RE: **K & K Properties - Industrial Flex Space - Site Plan - 22-07000017
2427-601-0031-000-8**

**Re: K&K Properties Site Plan – (East of S. 7th Street & N. of Farmers Market Road)
– Pre- Application Comments for March 23, 2022, Pre-Application Meeting**

Landscape Plan

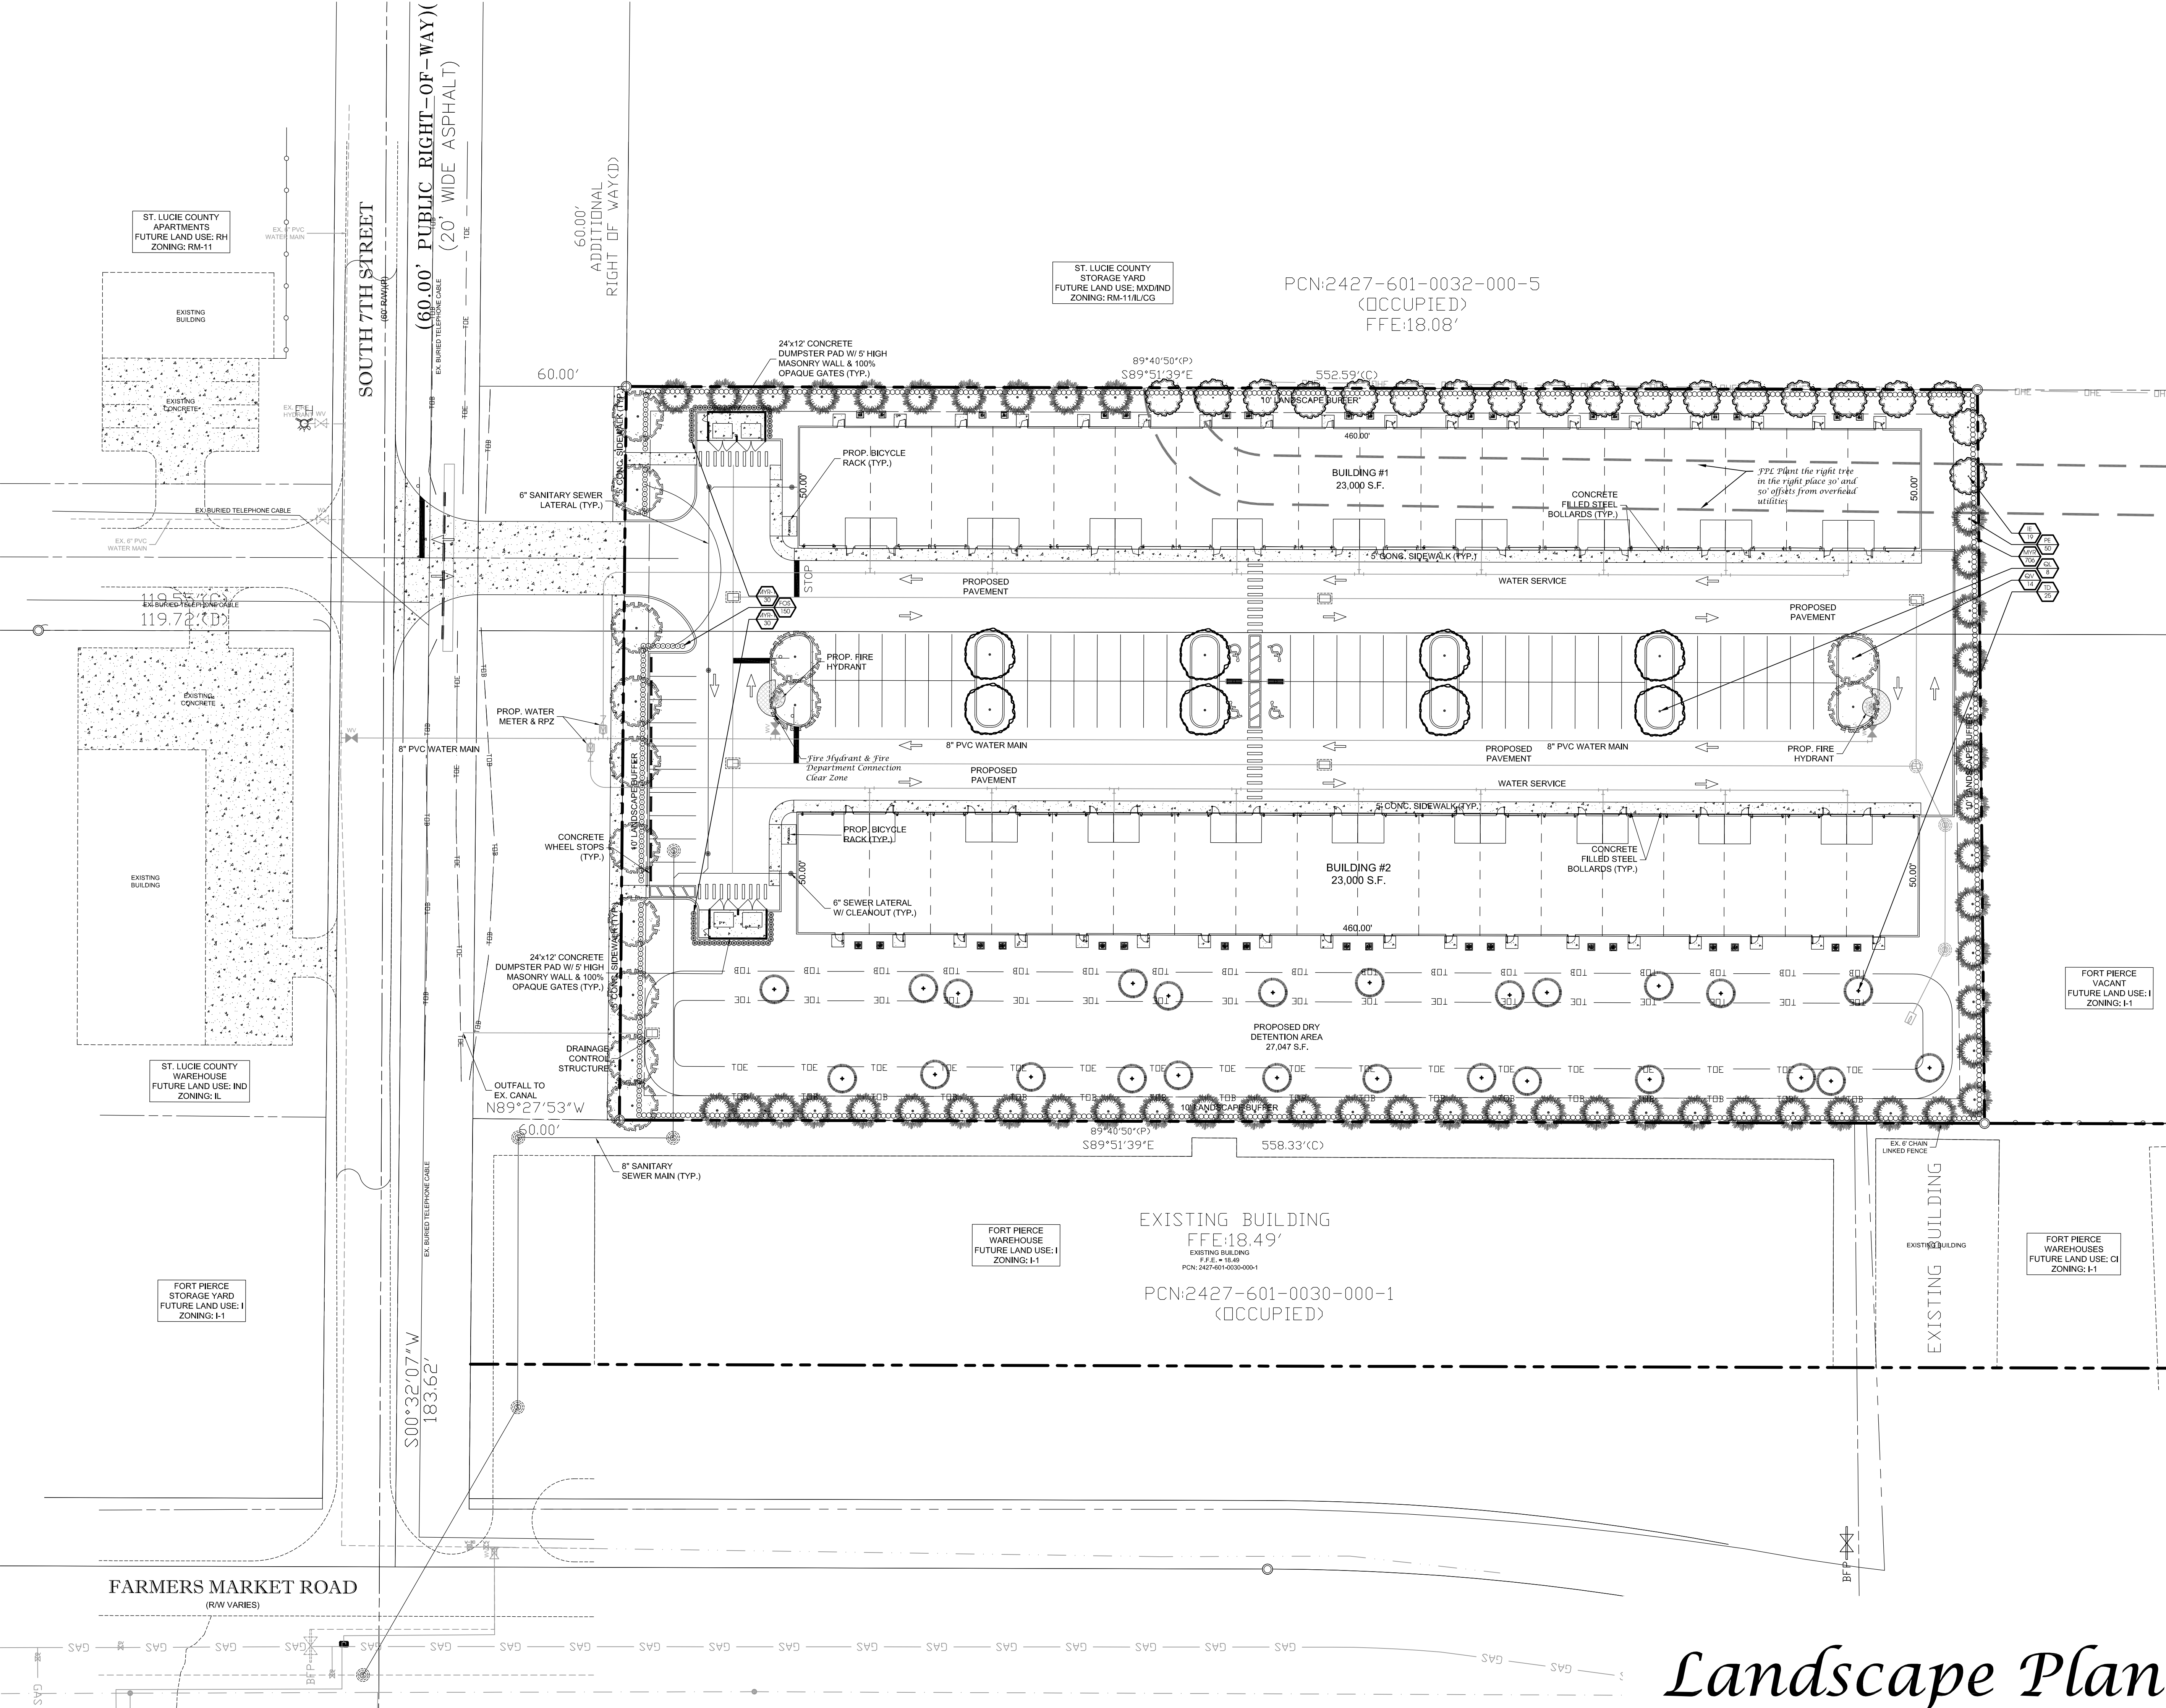
3. A Landscape Plan shall be provided at the time of Application that is signed and sealed by a Florida Registered Landscape Architect pursuant to City Code 123-37, General Landscaping requirements. The Landscape Plan shall include both interior and exterior landscaping.

16. Provide a color overlay on your submitted landscape plan. (Color each tree green on your landscape plan).

RESPONSE: Landscape plans have been included as part of the resubmittal package.

RESPONSE: Color Overlay shall be included during a subsequent submittal.
